CONSTRUCTION SUMMARY

Lindsay 2017 Developments Inc. / Sugarwood

Lot/Unit: 4 Phase/Building: 1 Model/Floor Plan: Buckhorn Lake (3704) Elev A 4Bed 2.5Bath

SCHEDULE "B-1"
Floor Plan

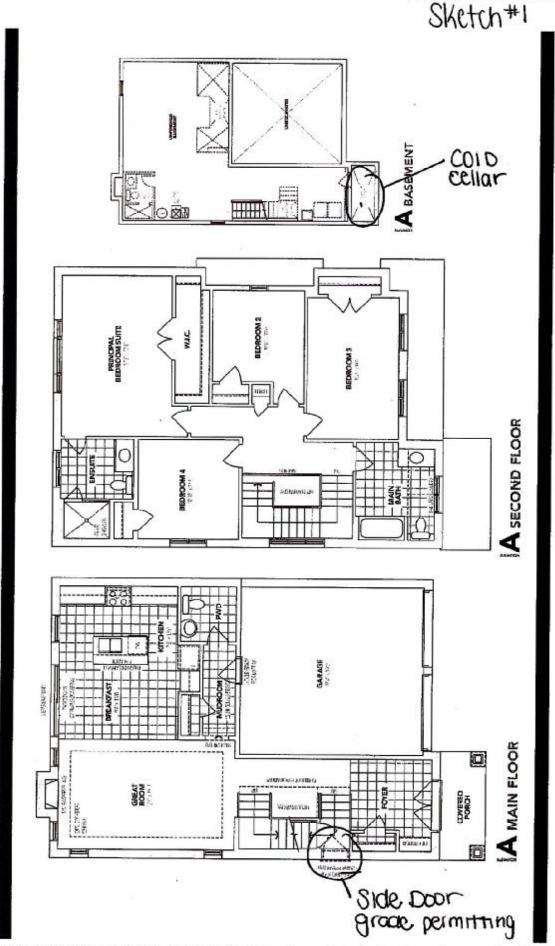
Inv. 5786	1 - To supply and install the optional side door (Grade Permitting) to the home see sketch #1	
Line 73813	Note:	
1Sep22 / 1Sep22

Inv. 5786	1 - To supply and install the optional cold cellar to the basement see sketch #1 for details	
Line 73814	Note: THIS UPGRADE TO BE COMPLETED BY THE CONCRETE AND DRAIN COMPANY.	
1Sep22 / 1Sep22
